ASSESSMENT REPORT

Section 75W Modification Pasminco Remediation, Boolaroo (MP 06_0184 MOD 3)

Figure 2: Cell 1

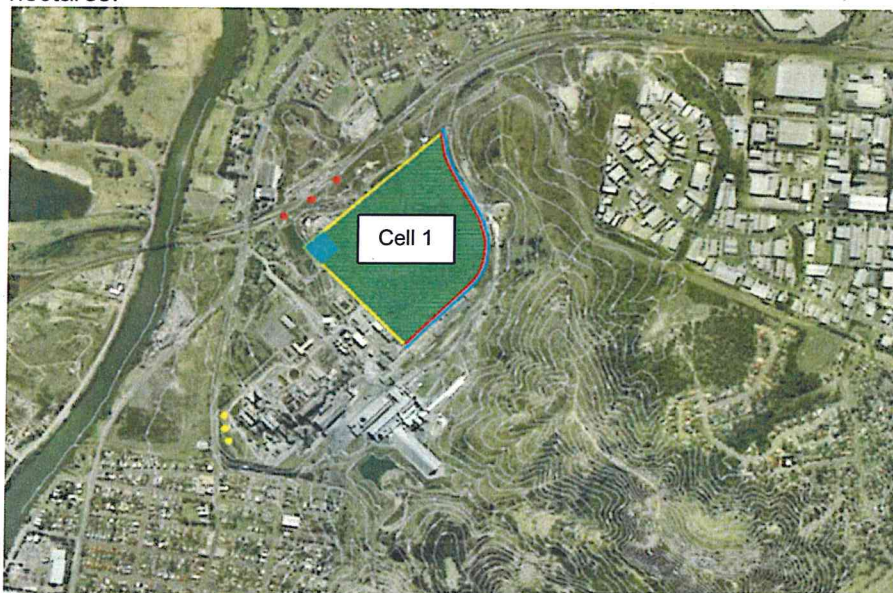
Contaminated materials are progressively placed in Cell 1, compacted in a controlled manner to a varied depth of up to 15 metres, and then sealed with an approved 'cap'. The cap is approximately 2.5 metres thick and its purpose is to minimise water infiltration into the cell (thereby reducing groundwater and leachate generation). The final land use of the cell surface is currently approved as 'passive' or no 'development'.

PCCS has reported that better than anticipated compaction rates have been achieved for the material already placed in Cell 1, which means that the material is stronger and less compressible than originally expected.

Figure 3: Concept of proposed cell capping system

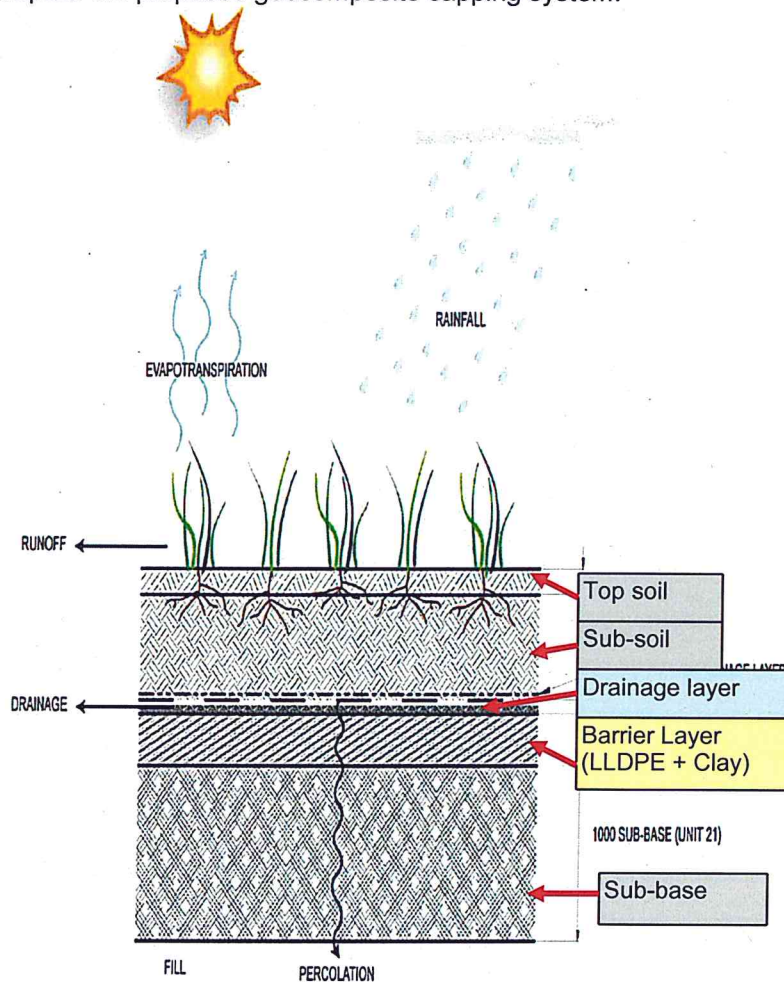
The proposed modification seeks to amend the cap barrier system from 600mm of clay material to a combination of 100mm clay with a 1mm Linear Low-density Polyethylene Liner (LLDPE) geomembrane (ie a Composite Liner). It also seeks to amend the drainage layer by incorporating a geocomposite drain to enhance the protection of the LLDPE liner below.

The **Site Auditor** considered that the altered design would not alter the effectiveness of the cap or increase the amount of leachate generated.

The Site Auditor reviewed the application and raised no concerns, stating that the revised barrier layer should be able to provide an equivalent performance to the clay only barrier, and the geocomposite drainage layer should be able to provide adequate drainage.

The EPA considers the cap changes are well justified and feasible, however it made a number of recommendations for material specifications and quality control during installation to mitigate the identified disadvantages of the revised cap (see Tables 2 and 3). Subsequent negotiations with

The EPA has also recommended that additional information should be provided by Ferrier in relation to installation methods, tests, inspections and other verifications to mitigate the identified disadvantages of the proposed cap including the potential for tearing and degradation of membranes from UV exposure. The Department considers that these construction quality assurance procedures in relation to the revised cell cap should also be included in the Cap Plan.

Finally, the Department considers that the Cap Plan should contain details of cap maintenance, especially in relation to the fact that the geocomposite drain has a higher potential for clogging. The Department is confident that with an approved Cap Plan in place, the environmental performance of the cell would not change.

Cell drainage	Cell barrier layer
<ul style="list-style-type: none"> • Top soil and subsoil layers shall be a minimum of 750 mm deep above the drainage layer (equal to that which is already approved). • The drainage layer must contain a tri-planar and high density polyethylene geonet which is manufactured or covered with a geotextile fabric on the upper surface (or a product of equivalent performance). • The internal drainage core of the geonet (or equivalent product) must be at least 10mm thick. • The drainage pipe system shall maximise water collection. Pipes are required to be placed in inverts (or similar). • Prior to the commencement of construction Ferrier is to confirm that the hydraulic transmissivity of the modified system is equivalent to the transmissivity of the approved gravel drainage system. • A high visibility marker barrier no less than 250mm above the geocomposite drain and LLDPE barrier shall be installed which does not impede the functioning of the capping system (this is required to compensate for the overall reduction in the cap depth as a result of reducing the clay layer by 500mm). 	<ul style="list-style-type: none"> • The cell barrier layer shall contain an LLDPE liner with a thickness of at least 1mm.

The Department concurs with the EPA's position, and believes that the EPA's recommendations (as detailed in Table 4 above) and requirements for detailed engineered drawings, can be incorporated into a recommended condition for Ferrier to address as part of a 'Cap Plan'. The Department has recommended that this 'Cap Plan' be submitted to the EPA and Site Auditor for approval prior to the commencement of construction of the revised cap.
